## CMB Meeting Minutes #147

REFERENCE Project No. M544.1, Contract No. 149 Task 1-8.02

SUBJECT: Configuration Management Board Meeting # 147 – Rev. No. 0

Sta. 164+60, Panel P-9

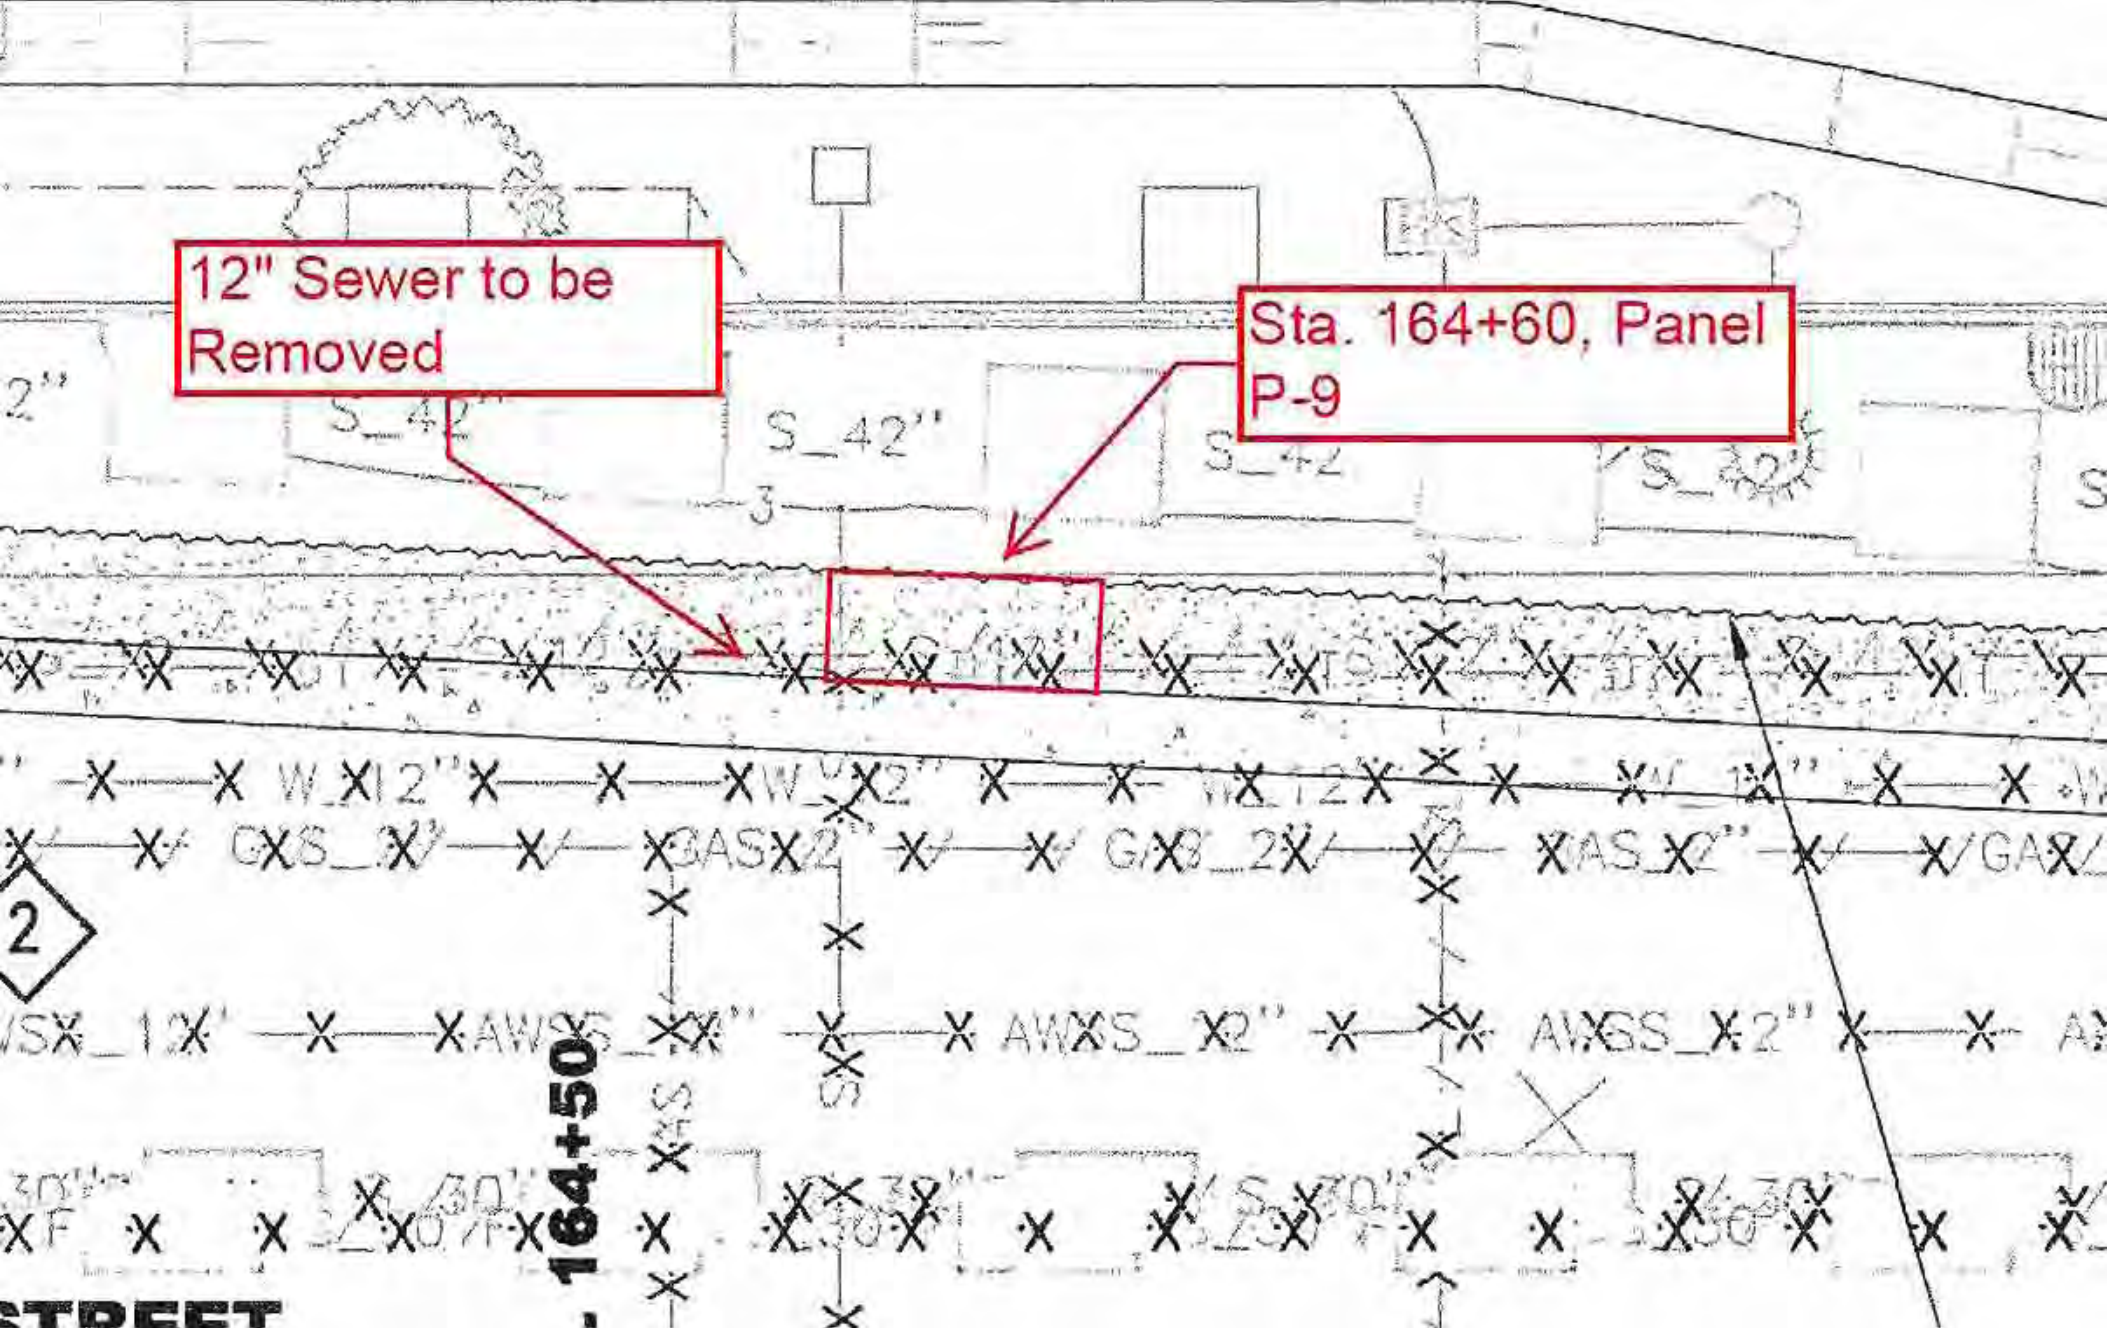
**Facts:** On November 7<sup>th</sup> 2012, the Contractor encountered concrete encasement around a 12 inch clay sewer pipe within Slurry Wall (SW) panel P-9 at the TBM Launch Box approximately 8 feet below the top of the SW guidewall. The concrete encasement caused the SW to deviate from the designed excavation limits. To correct the verticality of the panel excavation, the panel was backfilled with lean concrete and re-excavated as agreed upon by the RE.

**Justification:** Drawing UD-502, Rev. 0 does not indicate the presence of the concrete encasement within the footprint of SW panel P-9. The concrete encasement prevented SW construction from occurring as originally planned. RE has evaluated the conditions outlined in Article 3.04 and found that: conditions differ materially and conditions caused the scope of work to increase.

Sta. 164+97, Panel P-12

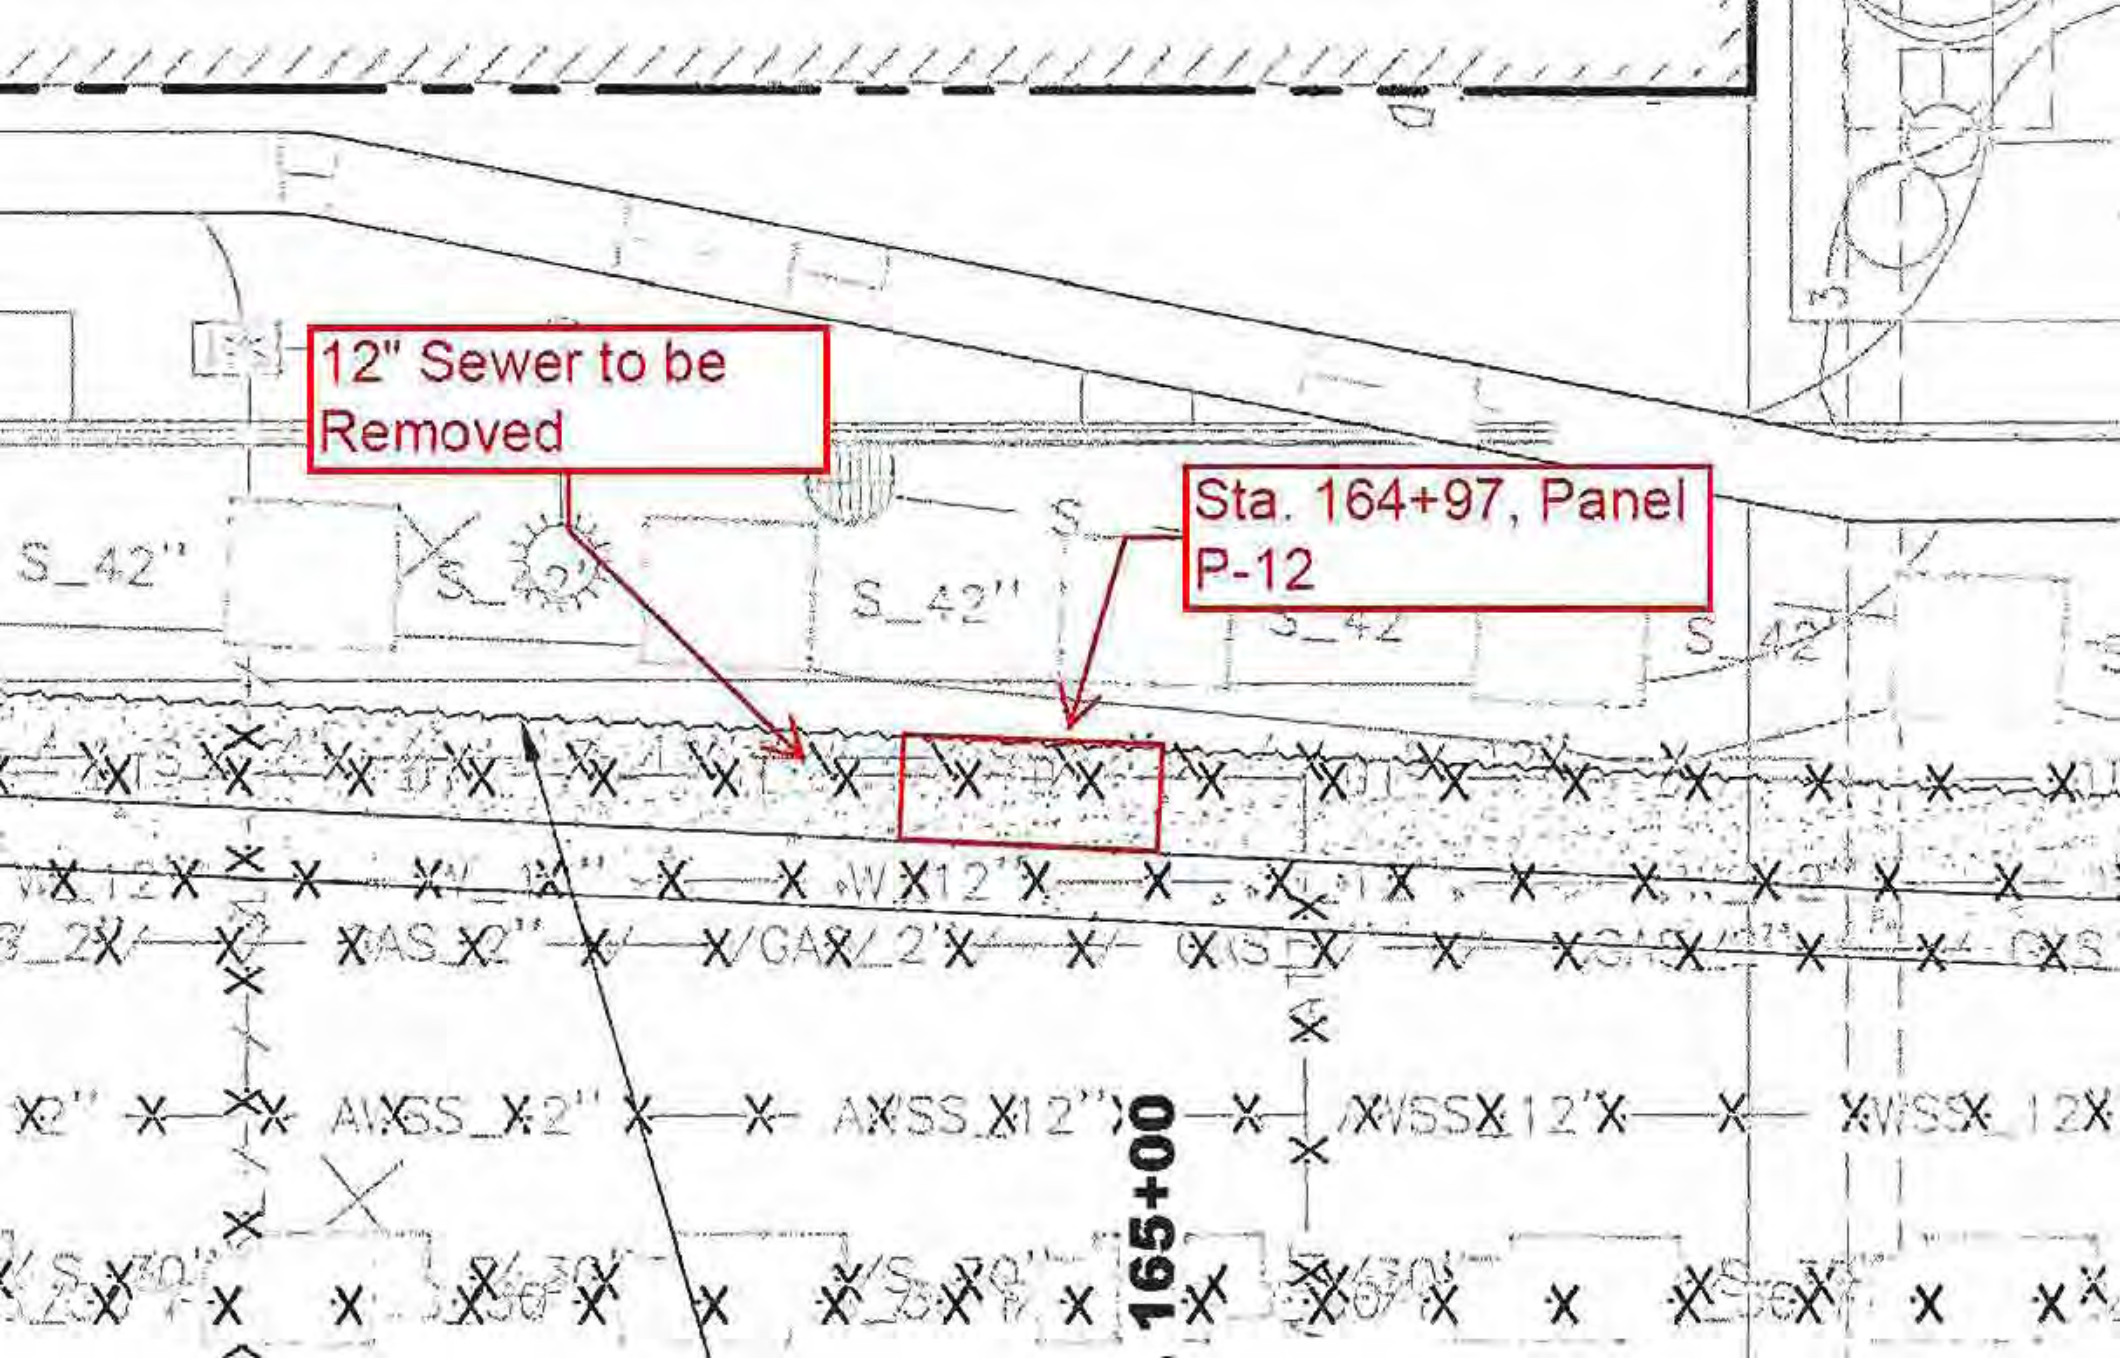
**Facts:** On November 13<sup>th</sup> 2012, the Contractor encountered concrete encasement around a 12 inch clay sewer pipe within Slurry Wall (SW) panel P-12 at the TBM Launch Box approximately 7 feet below the top of the SW guidewall. The concrete encasement caused the SW to deviate from the designed excavation limits. To correct the verticality of the panel excavation, the panel was backfilled with lean concrete and re-excavated as agreed upon by the RE.

**Justification:** Drawing UD-502, Rev. 0 does not indicate the presence of the concrete encasement within the footprint of SW panel P-12. The concrete encasement prevented SW construction from occurring as originally planned. RE has evaluated the conditions outlined in Article 3.04 and found that: conditions differ materially and conditions caused the scope of work to increase.

**SECTION VIEW  
POTHOLE NO. 1 (PH-1)  
LOOKING SOUTH AT APPROX. STATION 138+38**

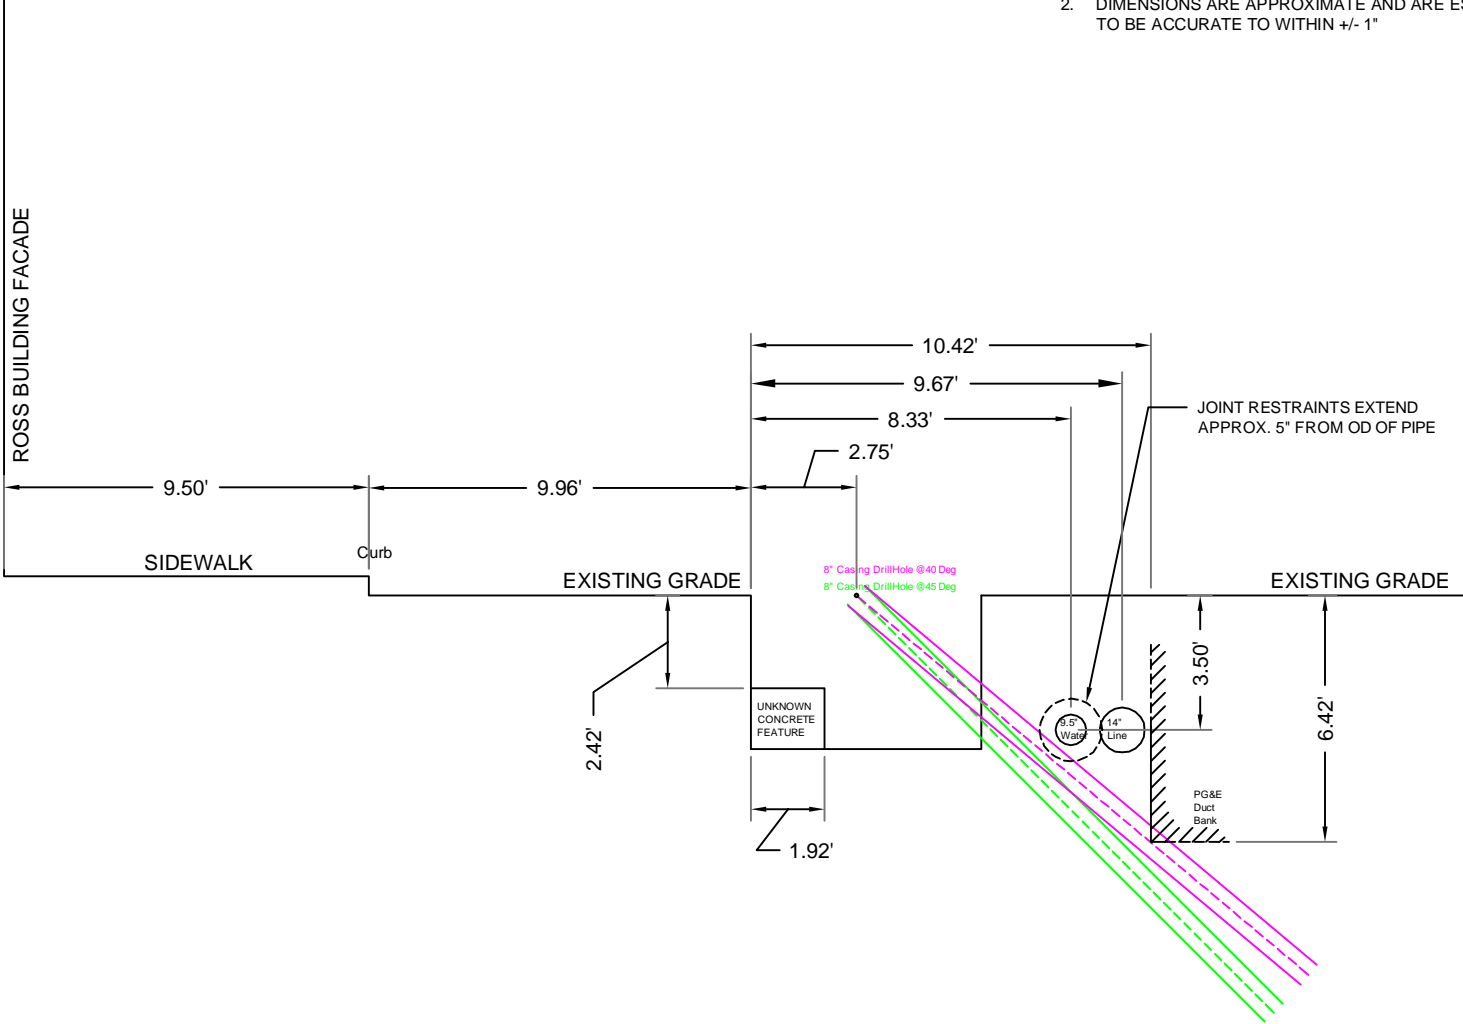
After further field investigation with PG&E and additional potholing efforts, it was determined that there was not sufficient room between existing utilities (known and unknown) to drill the compensation grout holes as designed. The Contractor was able to remove many of these obstructions in an effort to identify a clear window of space in which to locate the proximal points of the compensation grout pipe array. However, one of the obstructions consisted of what was originally believed to be a live 12" waterline which would have caused the proximal points to shift to the east to avoid the live utility. On 4/4/13, it was discovered that this utility was not actually the 12" live waterline and on 4/5/13, PG&E confirmed that the utility was actually a 12" abandoned gas line.

- Sketches 045 through 047. However, the Contract Documents, specifically the Utility Demolition and Utility Composite drawings, do not show whether the 12" gas line is live or needs to be removed.
4. The PGE electrical duct bank was deeper and further east than originally anticipated.
  5. The waterline shown on the drawings was further east than shown on the Contract drawings. See Field Sketches 045 through 046.
  6. A sub-sidewalk basement within the Ross Dress for Less building was discovered to have an unknown roof load capacity. This resulted in the need to bring in a smaller drill rig that could install the compensation grout tubes from the roadway and avoid installation on top of the basement.

\\sv6nas003\m544\FinalDesign\DRAWINGS\CS155-2\1254\SHEET FILES\02\_CIVIL\09\_WATER DISTRIBUTION\12540209WD202.dwg  
 tboyan Tue Dec 13, 2011 10:49 am WD-202

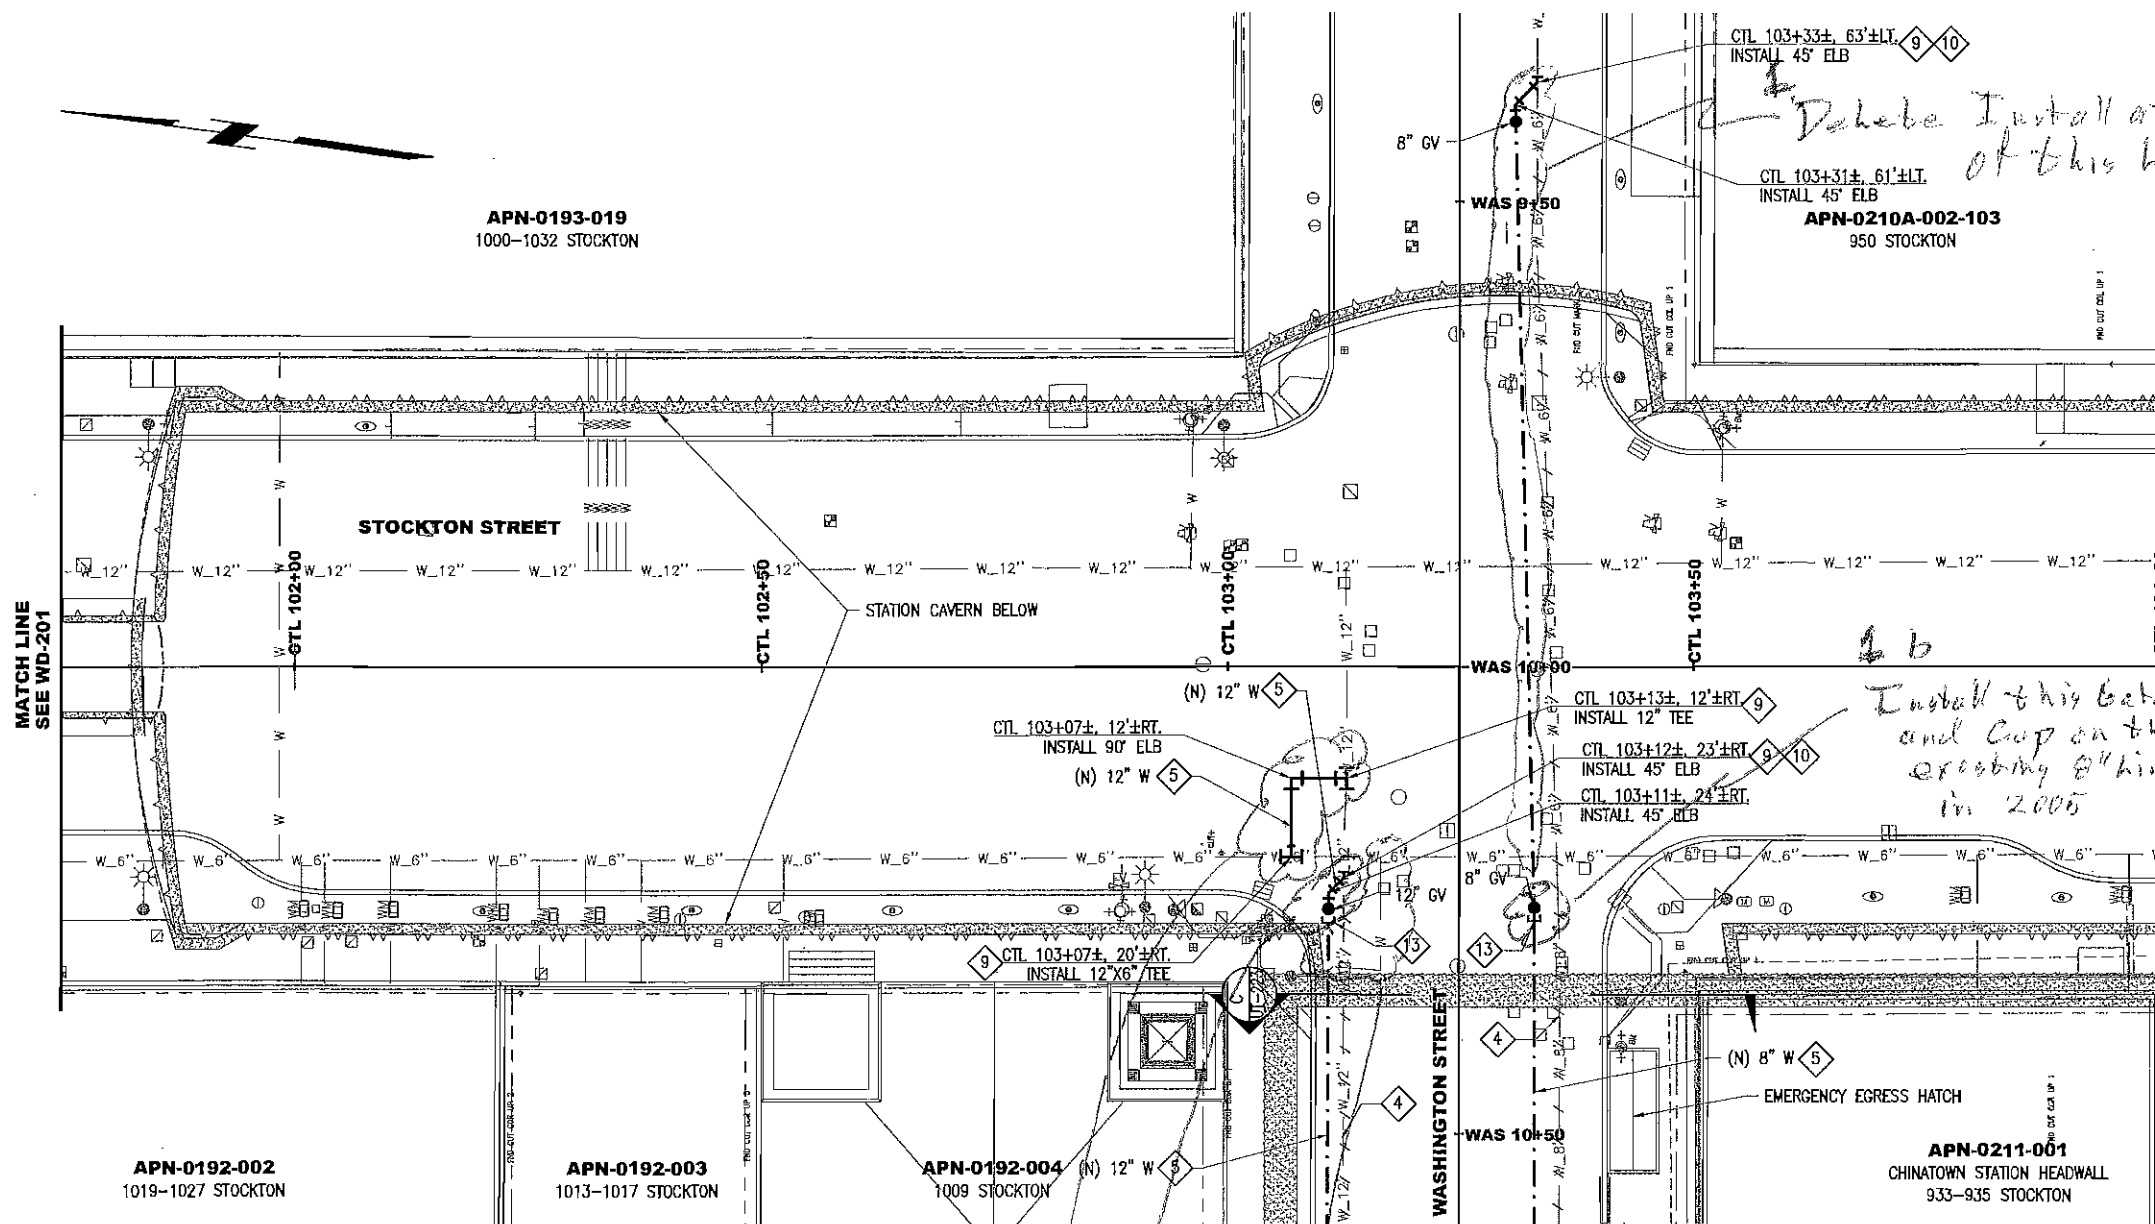
The scope of work is as follows on drawing WD-202:

1. Delete installation of the new 8" dia. DIP from CTL 103+33+\_ to approximately 10+25. Install a gate valve and restrained cap on this line and provide a thrust block as required. Any offset to this line can be done when the 8" line is installed over the completed station roof, a year or so down the line.

2. Pothole the existing connection of the 12" going up Washington St. to the 6" (now 8") which runs on the West side of Stockton. If it is possible to use part or all of this to provide the cross connect, this will become the cross connect, and delete the planned cross connect at CTL 103+13, 103-07+- 20'+-rt. Install connections needed to complete the cross-connect ensuring it will clear slurry wall.

3. If it is determined that the existing cross-connect cannot be utilized, then excavate for installation of the cross-connect similar to shown at CTL 103+13, 103-07+- 20'+-rt. Install new section of 12" line to approximately CTL 103+07, and remove the old cross-connect tee from the 6 (now 8") line. If a new cross-connect is installed, CDD will install a gate valve in it at the time of installation.

4. Delete installation of offsets on 12" line, and install a 12" gate valve and restrained cap and thrust block as required on the 12" line to the west. No offset are required until the 12" line is installed over the completed station roof, a year or so down the line.

2 Investigate if this cross-connect can be used or modified to connect to 12" line - if it can, connect it and delete installation of New Cross-Connect - if it cannot be used, remove tee & replace with 10" pipe
